APPLICATION NO.	FILING DATE	FIRST NAMED INVENTOR	ATTORNEY DOCKET NO.	CONFIRMATION NO.
10/593,795	09/21/2006	Witold Gajewski	703491 US	2794
	7590 08/04/200 RNATIONAL, INC.	EXAMINER		
337 MAGNA DRIVE			LIU, HENRY Y	
AURORA, ON L4G-7K1 CANADA			ART UNIT	PAPER NUMBER
			3657	
			MAIL DATE	DELIVERY MODE
			08/04/2009	PAPER

Application No.	Applicant(s)				
Office Action Comments	10/593,795	GAJEWSKI ET AL.				
Office Action Summary	Examiner	Art Unit				
	HENRY LIU	3657				
The MAILING DATE of this communication appears on the cover sheet with the correspondence address Period for Reply						
A SHORTENED STATUTORY PERIOD FOR REPLY IS SET TO EXPIRE 3 MONTH(S) OR THIRTY (30) DAYS, WHICHEVER IS LONGER, FROM THE MAILING DATE OF THIS COMMUNICATION. - Extensions of time may be available under the provisions of 37 CFR 1.136(a). In no event, however, may a reply be timely filed after SIX (6) MONTHS from the mailing date of this communication. - If NO period for reply is specified above, the maximum statutory period will apply and will expire SIX (6) MONTHS from the mailing date of this communication. - Failure to reply within the set or extended period for reply will, by statute, cause the applic

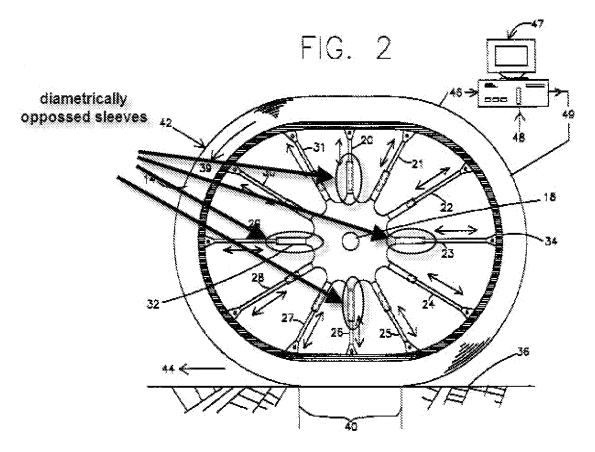
Regarding Claim 1, KUGELMANN teaches "a pulley (10) (Fig. 9, Fig. 10) comprising: a hub (12) configured to be mountable on a driving shaft (18), a rim (34), a driving connection (20) - (31) between the hub (12) and rim (34), enabling said hub (12) and rim (34) to rotate in unison, and a drive assembly extending from the hub (20) – (31)." KUGELMANN teaches "and operable to configure the rim between a circular profile and a non-circular profile (Fig. 1, Fig. 2, Col 3 line 44 – Col. 4 line 68)."

Regarding Claim 2, KUGELMANN as modified teaches "wherein said driving connection comprises at least two pairs of spaced diametrically opposed sleeves and said drive assembly comprises an actuator mounted within each of said pair of sleeves (Col. 3 lines 45-68)." See figure below. Extension of the ram rods is accomplished through hydraulic, electrical, mechanical, pneumatic means or combinations thereof.

Regarding Claim 3, KUGELMANN as modified teaches "wherein said driving connection comprises two spaced diametrically opposed sleeves arranged along a major axis and along a minor axis and said actuators are arranged to extend along the

major axis and contract along the minor axis, presenting an oval non-circular profile." See figure above. The major axis is the axis coinciding with ram rods (23) and (29). The minor axis is the axis coinciding with ram rods (20) and (26).
